TECHNICAL SERVICE BULLETIN

December, 1975

HEATER AIR INTAKE APERATURE

TR7

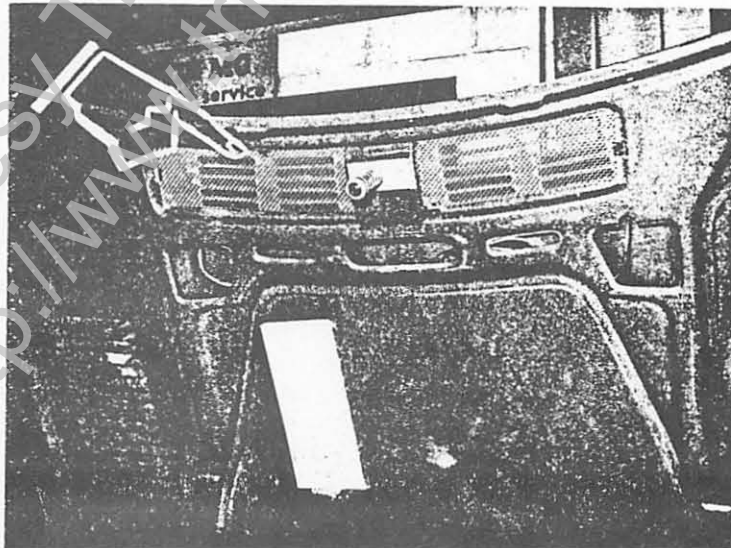
In areas where heavy snowfalls are not uncommon, the possibility exists where snow and ice can become impacted in the heater intake causing a restriction and therefore possible failure of the blower motor.

A screen is available, Part No. HAC-105, which can be installed to the underside of the hood intake aperature, (refer to diagram).
